PITT COUNTY TECHNICAL REVIEW COMMITTEE
DRAFT MINUTES – APRIL 23, 2025
GREENVILLE, NORTH CAROLINA

SOIL EROSION AND SEDIMENTATION CONTROL PLANS

CREEKWOOD (FORMALLY ARROWHEAD) REVISION: Located North of the Intersection of Arrowhead Road and NC 102 East within the Town of Ayden

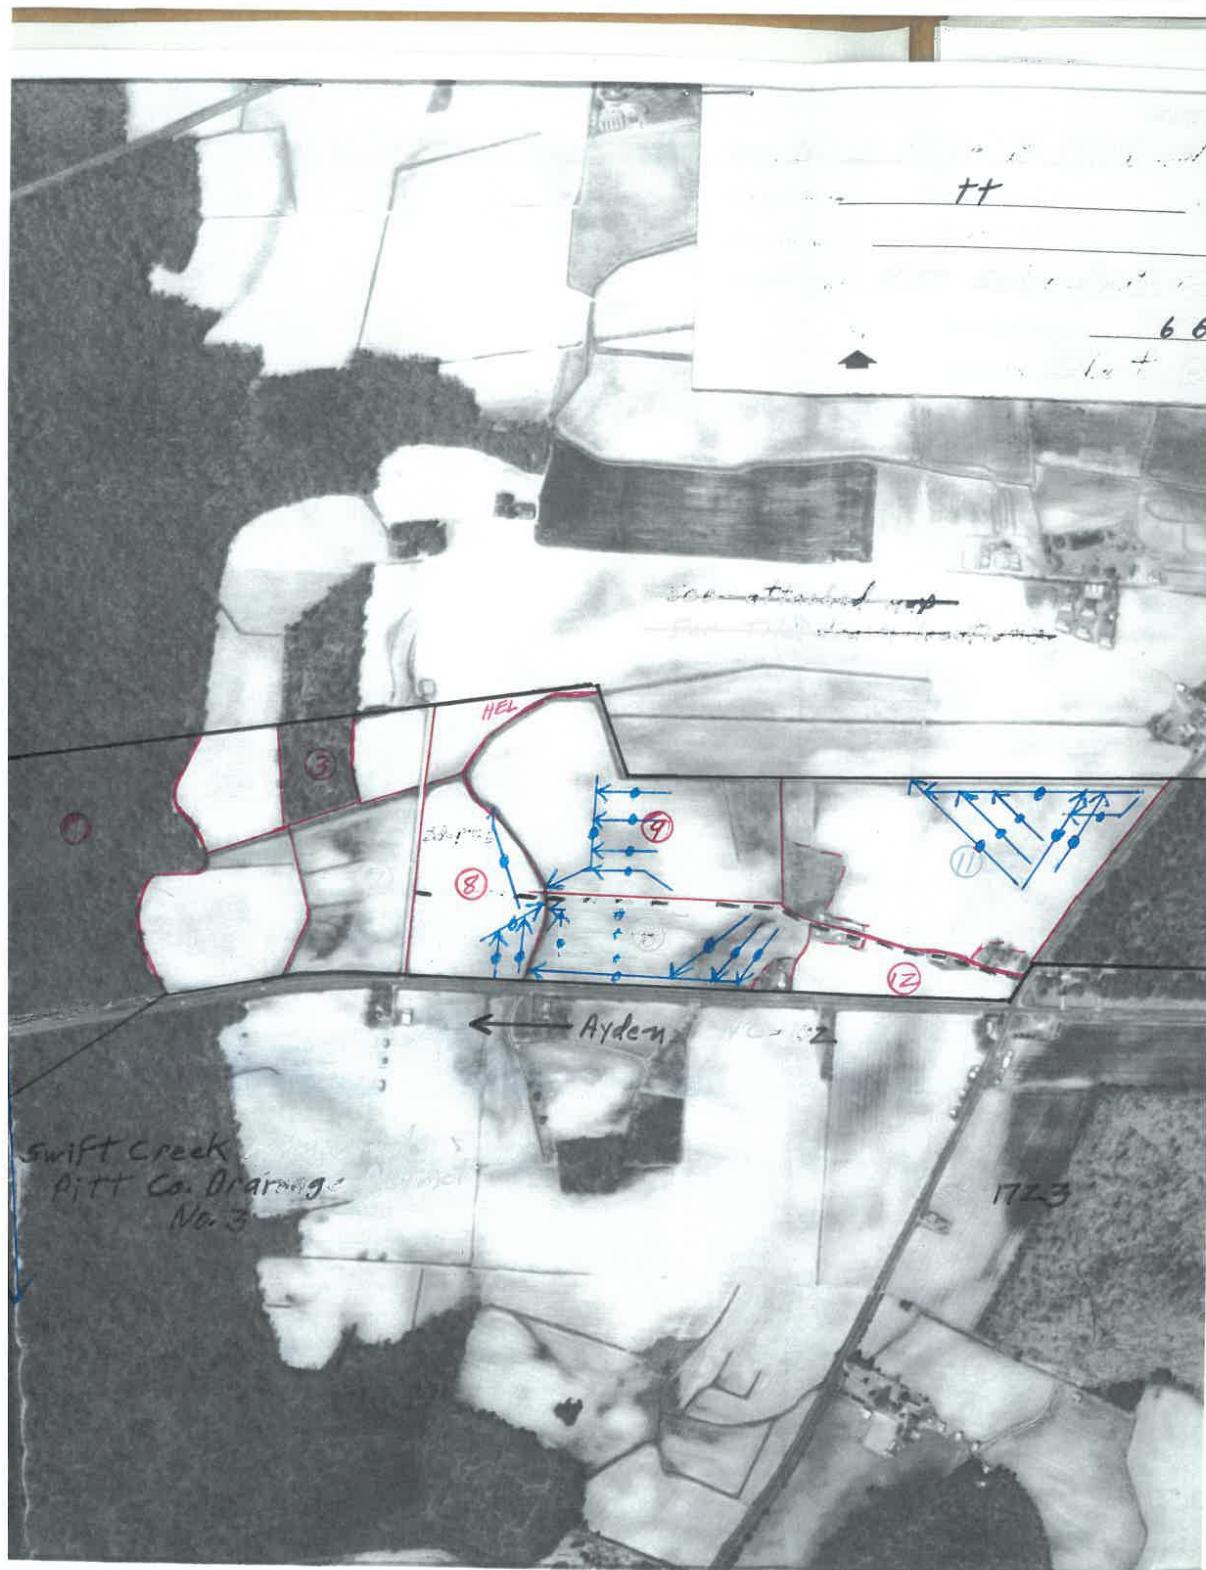
1. A floodplain development permit will be required.
2. A riparian buffer authorization and any other permits required for the crossing are required before the pre-construction meeting, or before construction begins in that section.
3. Show/label wetland limits on plans.

4. Please ensure that SESC plans are in accordance with all standards and regulations.
5. As stated in an earlier email, the state is amenable to either the current approved driveway configuration (driveway permit D021-074-24-00105) or the requirement of both right and left turn lanes on NC 102 allowing full movement to the driveway. If the option of both turn lanes are chosen, then a new driveway permit will be required.
6. Any other work performed within the NCDOT ROW will require encroachment agreements.
